TECHNICAL BULLETIN

MODEL/DERIVATIVE:
Freelander

Bulletin N°: 0073
CDS. ref: L8681bu
Issue: 1
Date: 04.07.01

PROBLEM:
SEAL - PLENUM COVER TO WINDSCREEN - ADRIFT FROM PLENUM COVER
The customer complains of the untidy appearance of the plenum cover to windscreen seal.

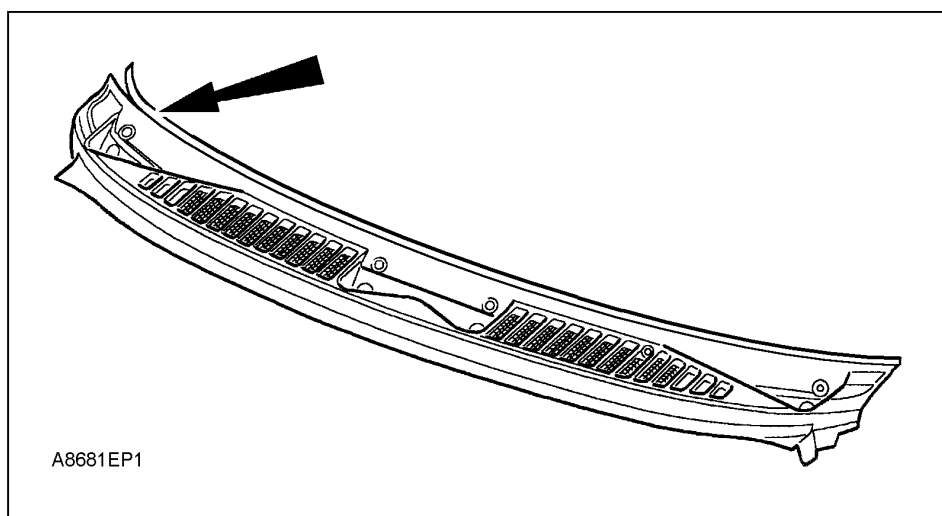
CAUSE:
Poor adhesion of the seal to the plenum cover.

ACTION:
On customer complaint of the above, secure the section of the seal which is displaced to the plenum cover, using the cleaning and adhesive materials detailed in *PARTS INFORMATION*.
Apply the adhesive sparingly to ensure that no excess is squeezed out when the seal is refitted.

PARTS INFORMATION:
CKU000020K - Adhesive Kit - containing adhesive, mixer unit and spirit wipe
NOTE: The adhesive is applied using the reusable applicator gun supplied in Adhesive Kit CKU000010K.
Dealers should already be in possession of this item following its use in Service Action A/D388 - Freelander Taildoor Glass.
It should therefore not be necessary to reorder CKU000010K.
